Subject ▶ Changes on screws fixing bearing box

For Models ▶ 9005B,9006B,9005BS and PC1100 (Disc grinders and Concrete planer)

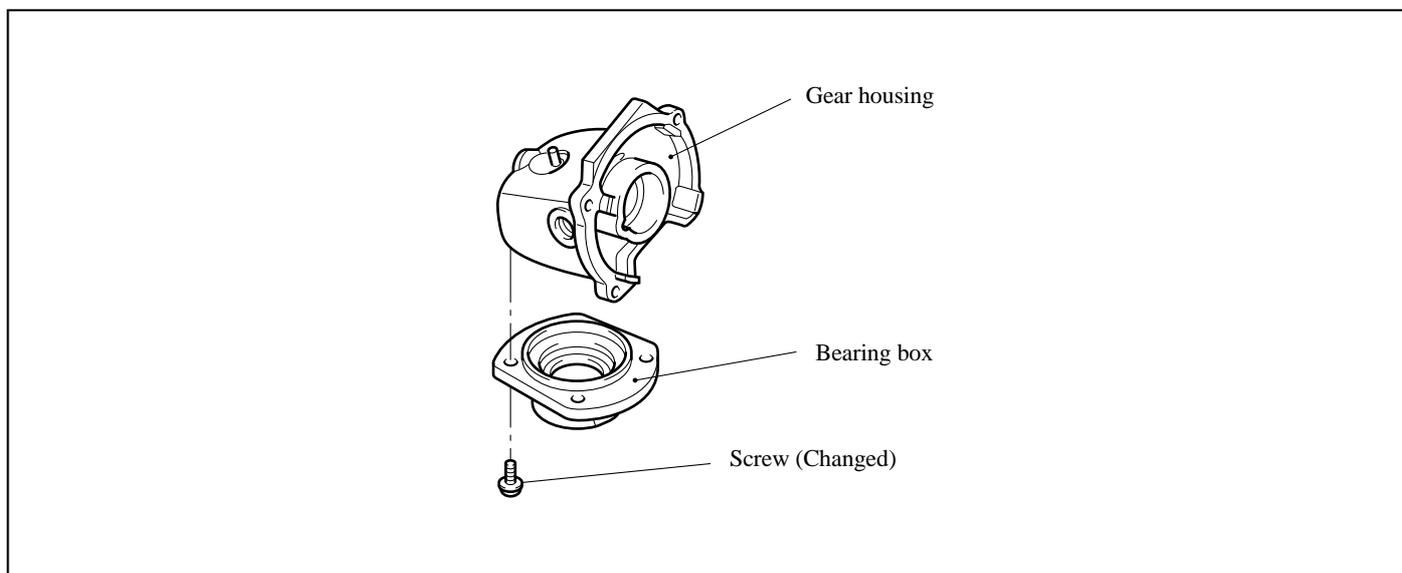
Description ▶ As described below, screws have been changed for fixing more securely.

Current	New
9005B,9006B 9005BS	Tapping screw	Hex.socket head bolt(with bond)
PC1100		Pan head screw

Item No.	Current part	Q'ty	I/C	New part	Q'ty	Note
31	Tapping Screw CT 4X16 ----- 266034-5	4	<=	Hex.Socket Head Bolt M4X14 ----- 266148-0	4	9005B,9006B,9005BS
29	Tapping Screw CT 4X25 ----- 266040-0	4	<=	Pan Head Screw M4X22 ----- 911141-6	4	PC1100
